**HAYSVILLE PLANNING COMMISSION
& BOARD OF ZONING APPEALS**

Haysville Planning Commission Staff Report

Subject: Preliminary Plat 2022-02 “River Forest 3rd Addition”
Applicant/Agent: Mr. James Klausman/ Mr. Travis Haizlip
Request: Replat of Lots 1-15, Block B, Lots 13-27, Block C, and Lots 1-9, Block D, all in the River Forest 2nd Addition located in the Southwest Quarter of Section 32, Township 28 South, Range 1 East of the 6th P.M. Haysville, Sedgwick County, Kansas.
Site Size: 13.32 acres
Zoning: Residential
Location: Delos St and Karla Ave.
Meeting Date: March 23, 2023
Presented By: Jonathan Tardiff, Planning and Zoning Administrator

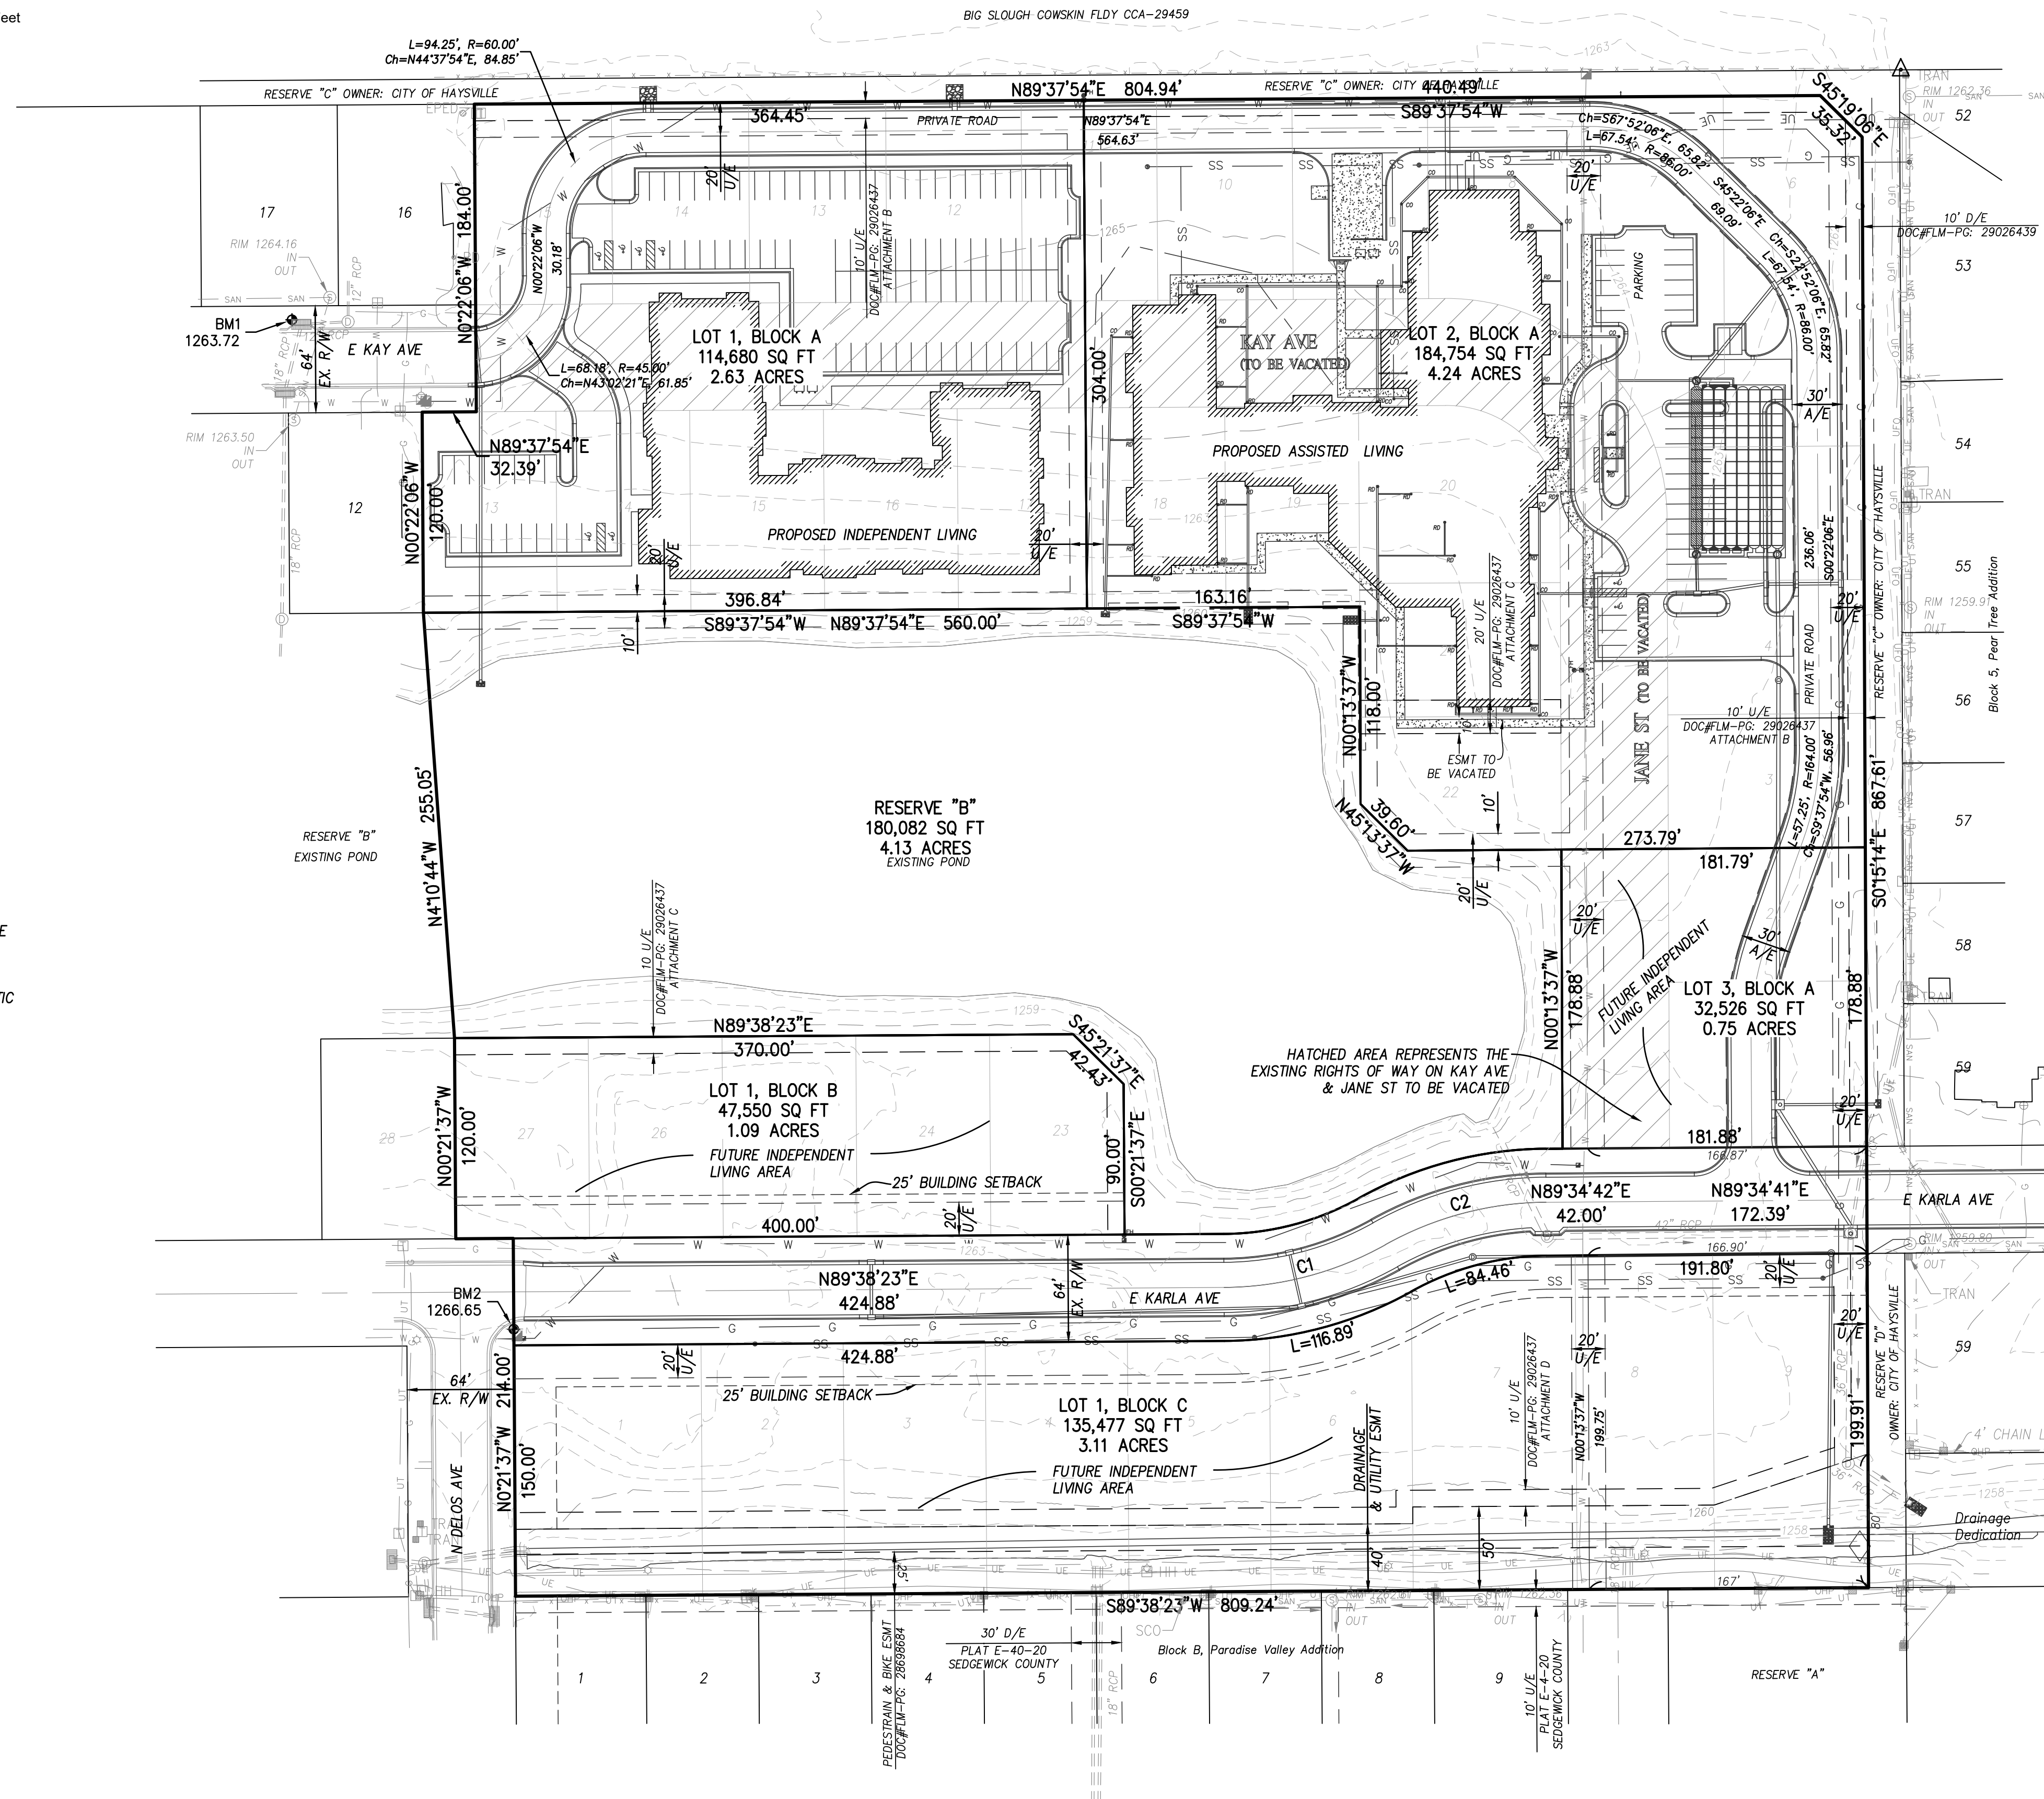
- What is the intent to handle future expansion of undeveloped space as it relates to drainage? Creating a separate drainage plan/study as development occurs or should it be handled now? Calculations in the report show it remaining as pervious area for proposed conditions.

- Please provide a plan sheet showing structure numbers as they relate to Appendix C for our review of the calculations.
- Appendix C calculations appear to only analyze the proposed pipes and not the existing pipes that they tie into on the downstream end. Since the existing pipe will have a backwater effect on the overall system, please revise the calculations to include the system with the existing pipes as well. Running calculations without the existing pipes will not provide an accurate analysis for HGL’s.

- Something seems off with the hydrologic calculations. If proposed subbasin 2 has a larger area and a higher average curve number due to the added impervious area versus the Existing subbasin 2, why are the flow rates of the proposed condition

subbasin 2 smaller? Why does the change-in-flow go up and down for some of the subbasins as summarized in the table at the top of page 5 in the report? The pre-developed 10-year flowrate for subbasin 5 seems like a typo (looks like it maybe should be 0.34 cfs). Please explain or revise as needed.

- Since the flowrates for the proposed subbasin 2 should be larger than the existing subbasin 2 flowrates, and this subbasin flows directly into the pond, what is the impact to the stage-storage relationship of the pond? Is analysis of the pond needed? The pond outlets through a pipe that connects to the overall storm sewer system being modified with this project. Do downstream modified pipe sizes/flowrates to the overall system impact the pond drainage?

- Please provide details of the underground storage system and the associated drainage calculations for our review.
- It's difficult to tell on the plan sheet provided which subbasins drain into the underground storage system (which appears to be located under the parking lot). If subbasins 50 through 65 are supposed to drain to the underground storage system, how do they flow towards its location if their flow enters the storm sewer system downstream of the storage unit?

- Please provide the water quality calculations related to the results provided in Appendix B.
- The original plat included single-family lots in this area. While the proposed development may increase runoff compared to single family, surface drainage from this entire property should be discharged into the adjacent existing pond.

- Where possible, combine piping systems to minimize the number of discharge points into the pond (for easier maintenance)
- The existing pond will provide some stormwater detention if the size is sufficient. Can the underground tank stormwater detention system located near the east entrance to the Assisted Living building be eliminated or reduced in size??

- Provide updated Drainage Plan with the modified storm sewer system and provide maximum water elevation in the pond based on the 100-year storm. Compare proposed stage-storage-discharge to existing conditions. Some additional flood storage may be required if the existing pond is not big enough. The proposed maximum water surface elevation in the pond should not exceed the elevations established in the original plat since existing homes have been constructed to that elevation. This will probably affect some of Riley's comments.

- Show water and sewer service to the Proposed Independent Living building.
- Portion of the existing N-S water line will need to be relocated around the proposed building entrance canopy.
